Wilson Road, Huyton
Liverpool

Unit A1
GA Building Elevations

7182-104 Rev C01

West (Yard Side) Elevation

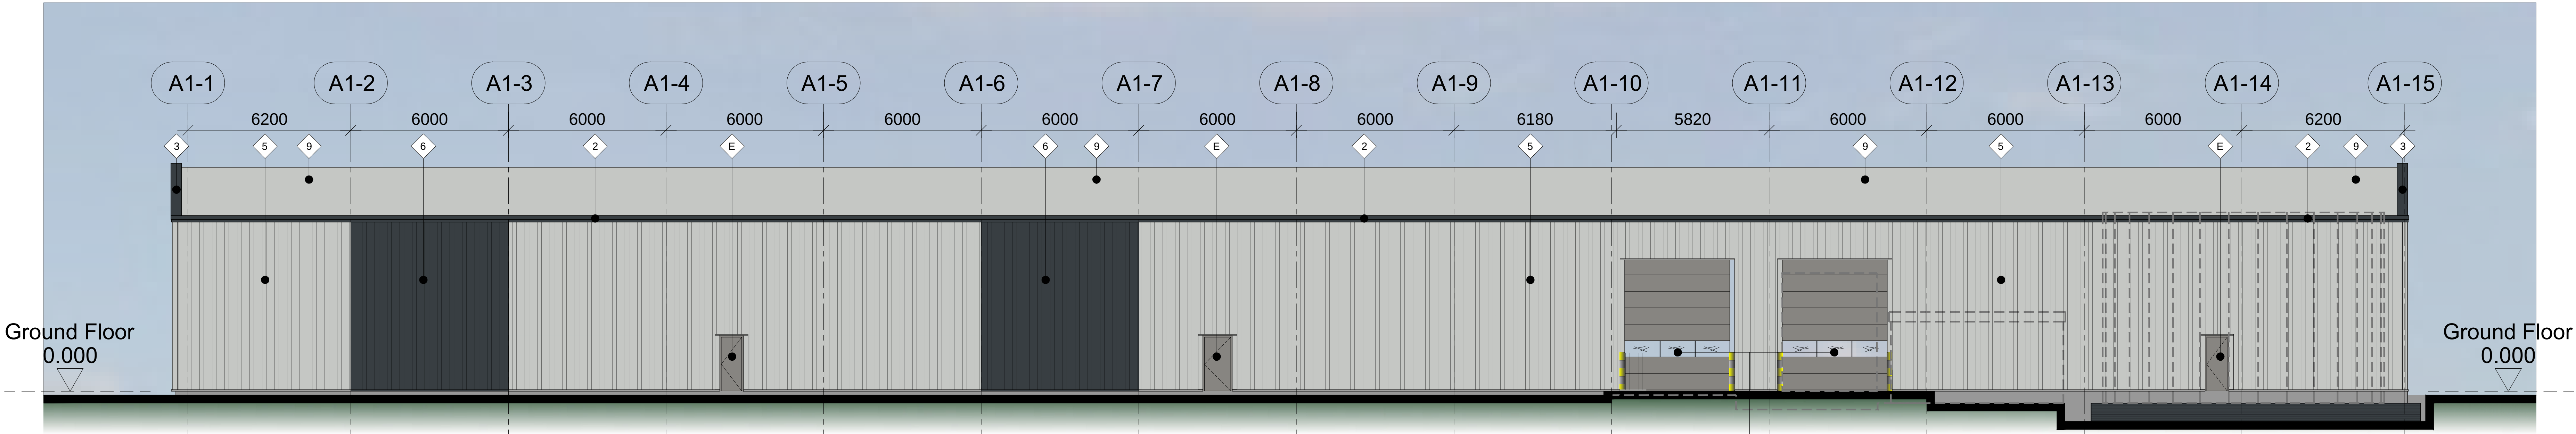
COL 08.10.25	Construction Issue.	gh
PO4 23.07.25	Existing cladding on West Elevation now to be over clad with new instead of cleaning and repainting. Extent of fire boundary condition noted.	rpw
PO3 11.07.25	Legend revised to differentiate between painted and NOT painted existing cladding (1b & 1c).	rpw
PO2 28.05.25	Changes to Signage.	rpw
PO1 28.05.25	Changes to South elevation between GL's 3 & A1, issued for Tender.	rpw
no.	date	revision
		by
